QUESTIONS & ANSWERS #2 TO:

Title-Sujet Replacement of Parks Canada storage tank and distribution systems for petroleum products		Date September 12, 2013
Solicitation No. - No. de l'invitation 10130584	Client Ref. No. – No. de réf du client.	
GETS Reference No. – No de reference de SEAG		
Solicitation Closes L'invitation prend fin – at – á 02:00 PM on – le 2013-09-17	Time Zone Fuseau horaire - Eastern Daylight Savings Time (EDT)	
F.O.B. - F.A.B. Plant-Usine: <input type="checkbox"/> Destination: <input type="checkbox"/> Other-Autre: <input type="checkbox"/>		
Address Inquiries to: - Adresser toute demande de renseignements à :		
Annie Roy		
Telephone No. - No de téléphone 613-938-5752	Fax No. – No de FAX: 613-938-5785	
Destination of Goods, Services, and Construction: Destinations des biens, services et construction: Havre-St-Pierre, Qc		
Vendor/Firm Name and Address Raison sociale et adresse du fournisseur/ de l'entrepreneur

QUESTIONS & ANSWERS #2

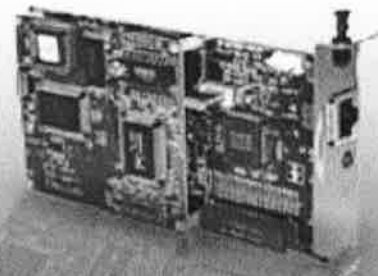
Q #1) We would like to get some details (brand, exact model) regarding the PXCM controller mentioned at article 6.2.2.4.1 of the technical specifications? In addition, item 6.2.2.4.1 says that the controller must be installed in the panel, as shown on the drawings, but this detail does not appear on the drawings.

A #1) *The existing panels will stay on site and the Contractor shall provide a Veeder-Root's Ethernet-IP Communications Card with a Veeder-Root's TLS-350. The card output will be connected to the existing communication module located above the electrical panels and the phone modem. See the attached technical sheet.*

Extrait du dessin # 121- 23520 - E04

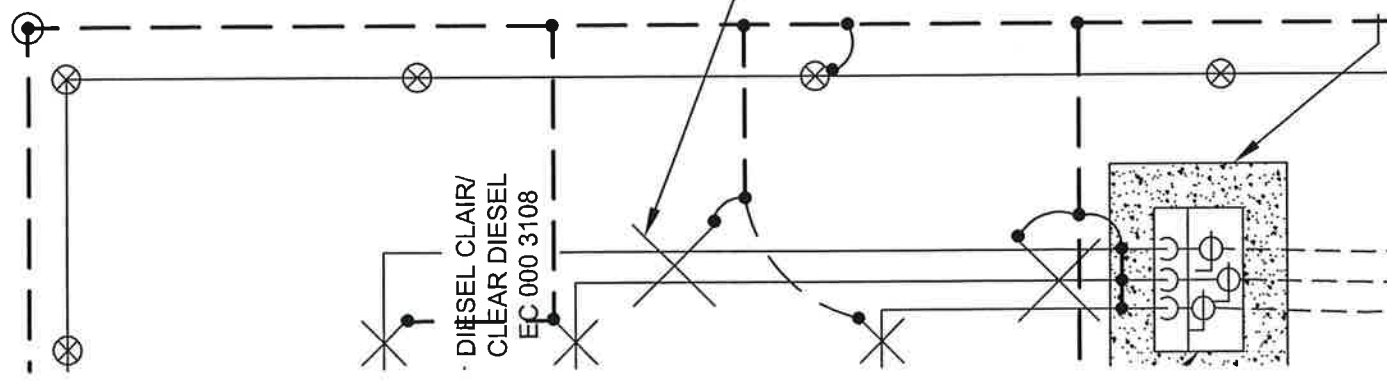
Q #2) What is the location of the existing electrical panel for the pump and the unroller (drawings 121-23520-E-001 and E-002)?

A #2) *See sketch drawing and photo attached.*
